MEMORANDUM

Subject: Process Follow-up for Approval of Synthetic Roofs in the Historic Districts and on Locally Landmarked Structures

TO:	Chairman Grinnell and members of the Historic Preservation Commission
DATE:	April 24, 2024
FROM:	Abigail Vollmers, Senior Planner
SUBJECT:	333 East Woodland Road – Proposed Roof Replacement with Non-Historic Synthetic Material

TO:	Chairman Grinnell and members of the Historic Preservation Commission
DATE:	April 24, 2024
FROM:	Abigail Vollmers, Senior Planner
SUBJECT:	333 N. Green Bay Road – Landscape, hardscape, and fencing

FENCE PLAN

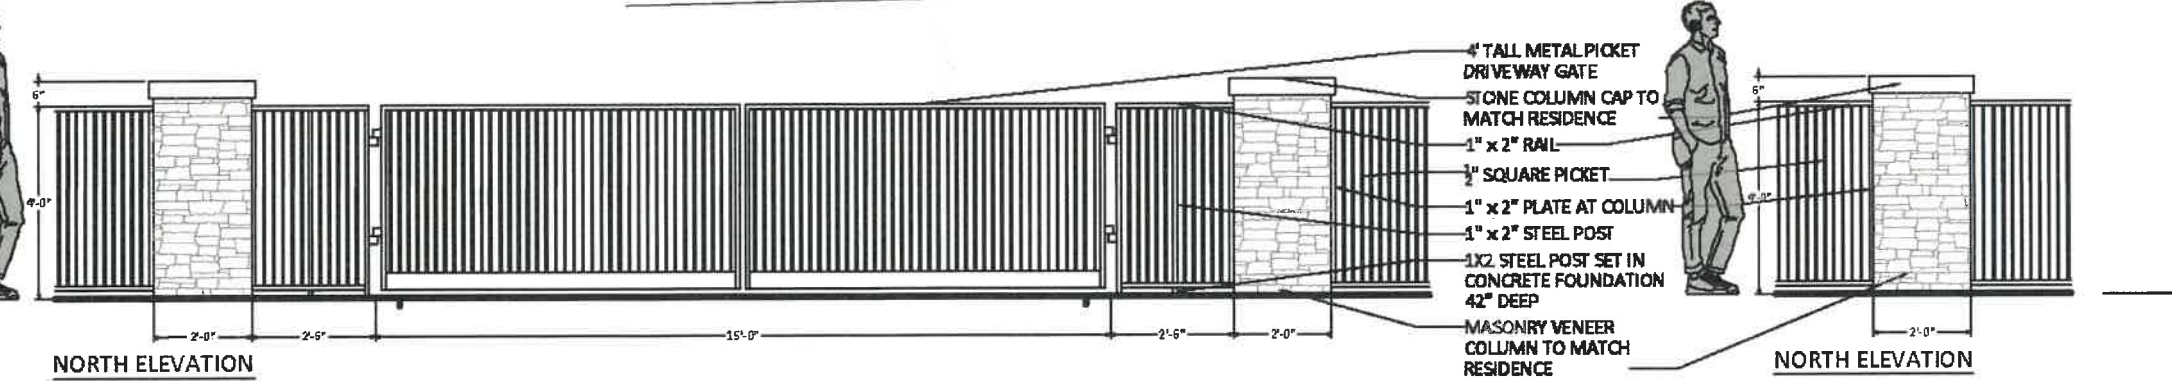
Provide comment and direction on the appropriateness of the fence styles proposed around the property in relation to the streetscape and surrounding residences.

Continue consideration of the fencing to allow review and modifications based on the Commission's and direction and to address the following comments.

1 4' METAL PICKET DRIVEWAY GATE WITH COLUMNS SCALE: 1/4" = 1'-0" BLUE

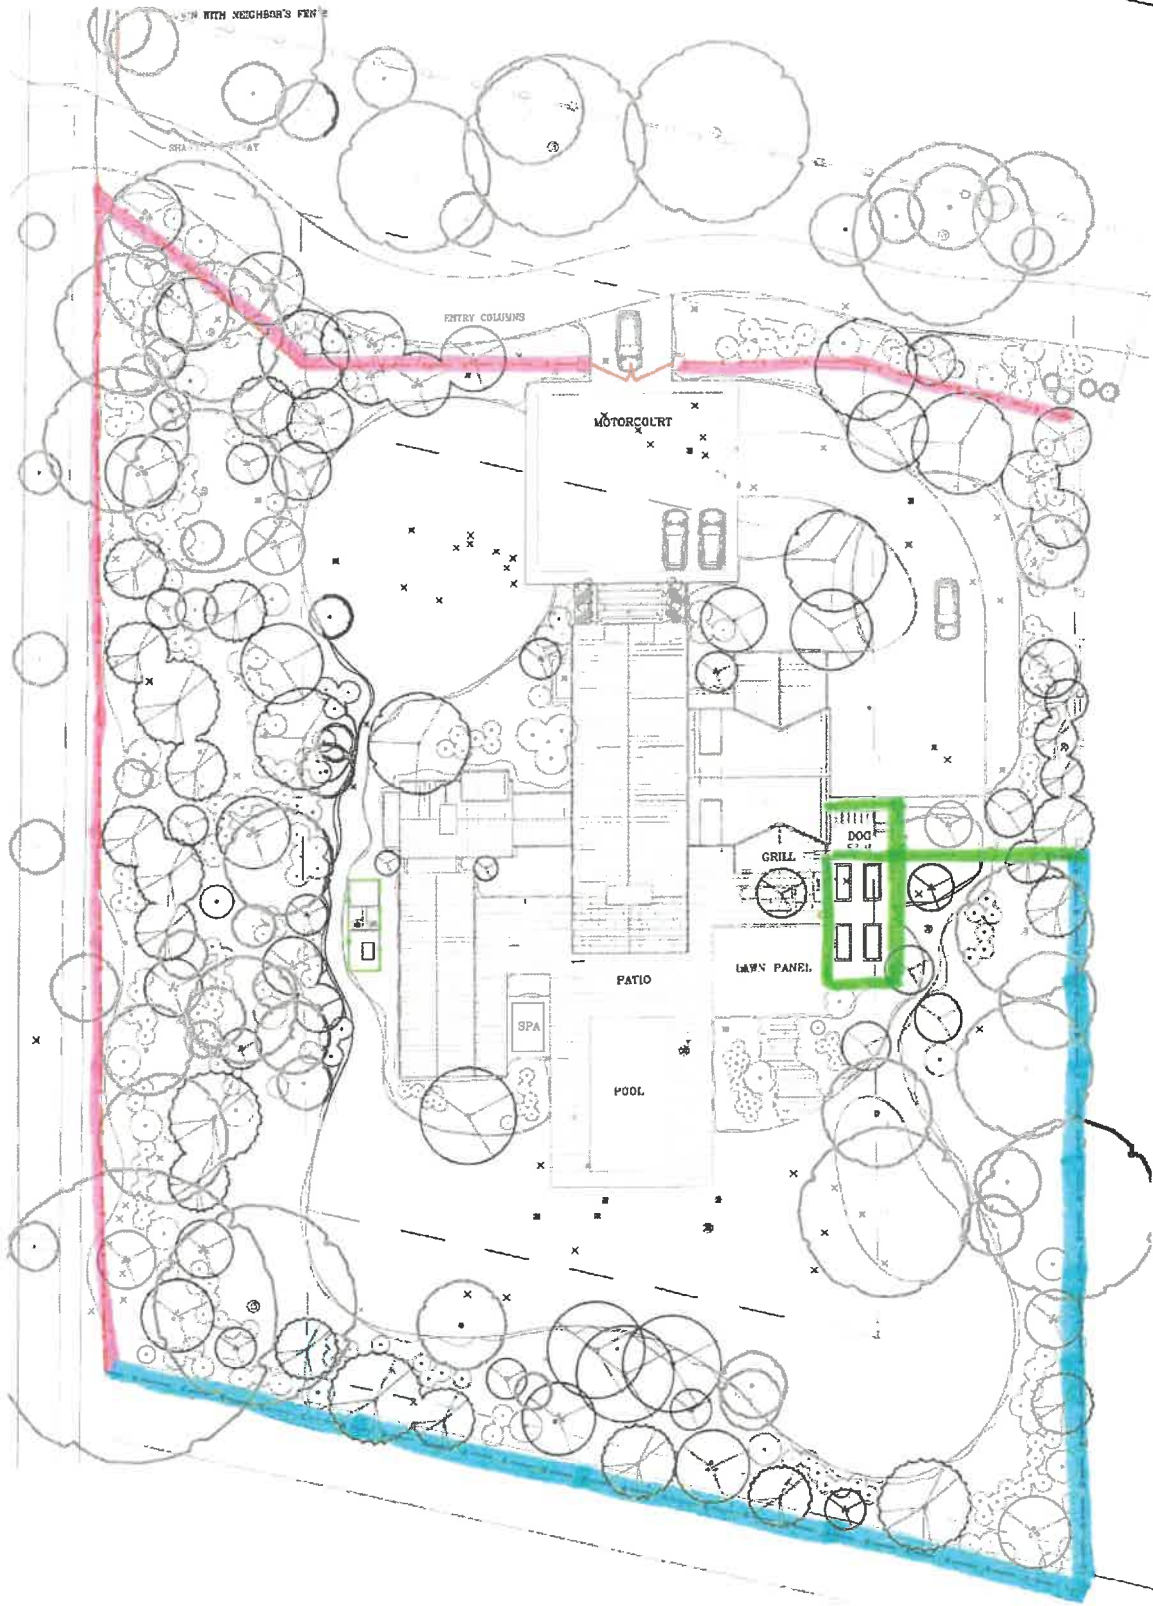
Staff Recommendation: The plans submitted for permit shall include a dimensioned plan to verify that a typical delivery truck (a box truck) can pull completely off the shared driveway, and on to the apron in front of the gate, with sufficient space for the gate to open.

Staff Recommendation: The plans submitted for permit shall include a detail of gate controls and mail/package delivery components and where they are located on the pillars.

4. If the existing piers at the driveway entrance are to remain, provide detailed plans reflecting the transition between the new fence and the piers.

LANDSCAPE PLAN

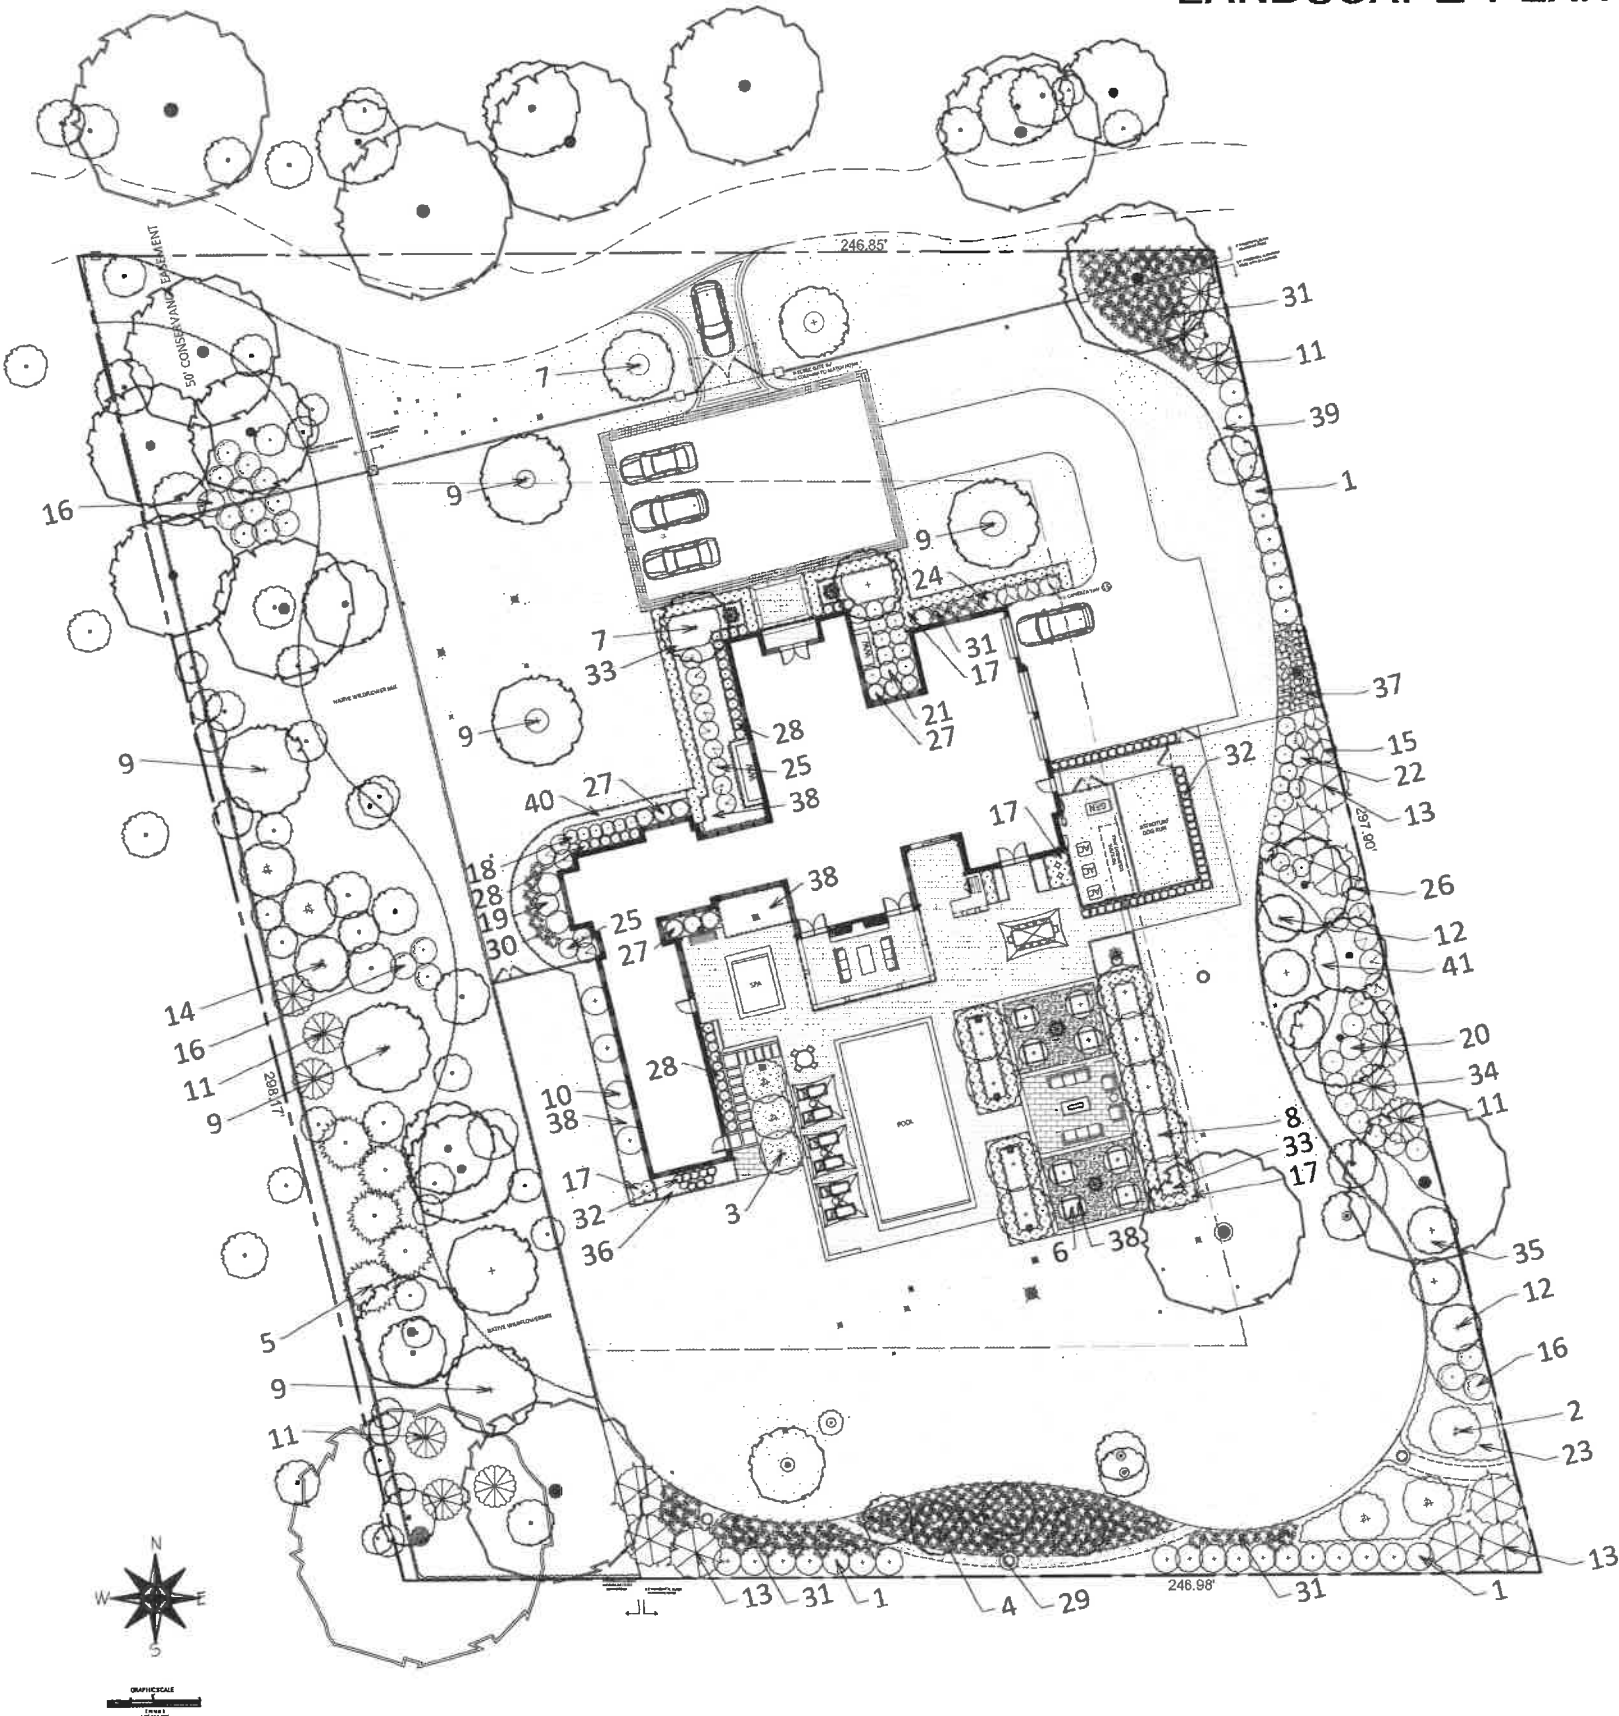
The landscape plan as presented includes 213 inches of replacement trees. On the final landscape plan submitted for permit the replacement inches will need to be clearly detailed.

LIGHTING PLAN

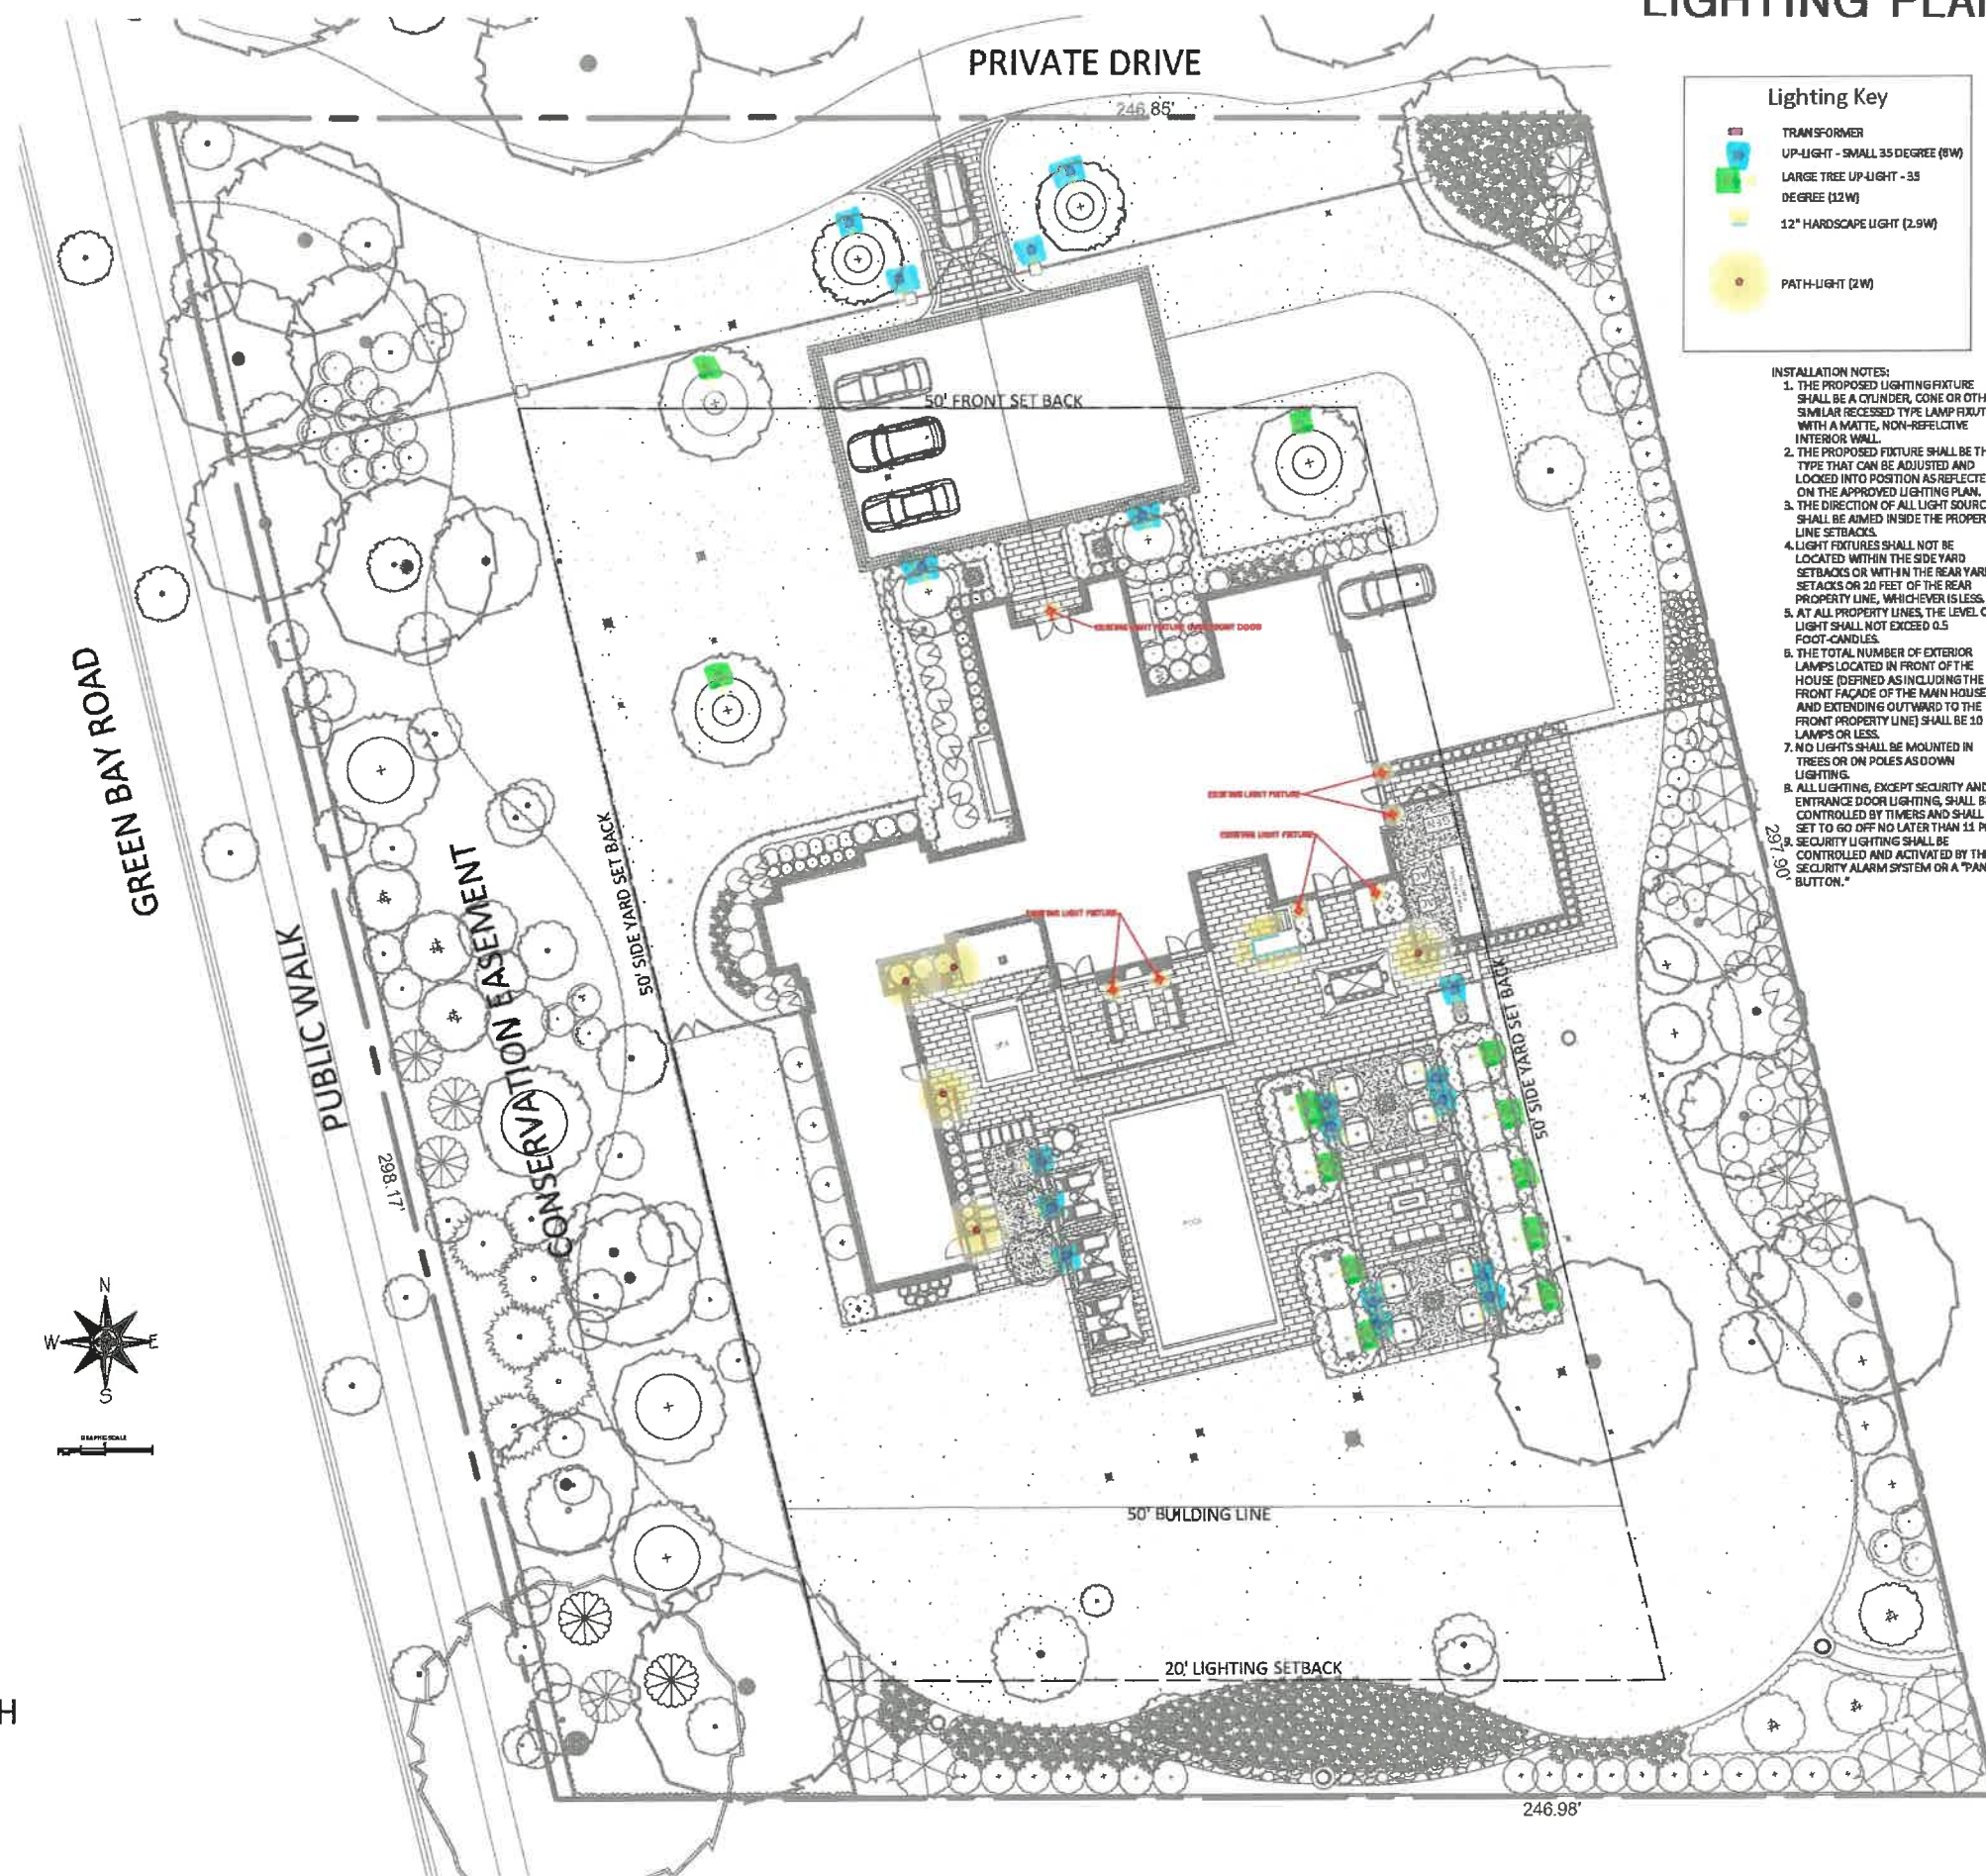
The lighting plan consists of ground mounted tree up lights within the building setbacks on the west, south, and east sides, path lighting around backyard pool deck and patio areas, and hardscape lighting at storage areas on the patio. On the north side of the property four tree up lights are proposed near the gated entry. The type and location of the lights is consistent with the City's Lighting Guidelines however the fixture cut sheets are missing from the package and will be needed to be submitted for permit in order to complete the lighting review.

1. The proposed light fixtures to be mounted on the exterior walls of the home, noted as existing light fixtures on the plan, must be submitted for review prior to rough in wall inspections. Cut sheets for all light fixtures shall be provided and all fixtures, except those illuminated by natural gas at low light levels, shall direct light down and the source of the light shall be fully shielded from view. All exterior lights shall be set on automatic timers to go off no later than 11 p.m. except for security motion detector lights. All exterior lighting shall be sensitive to the dark sky character of the neighborhood.
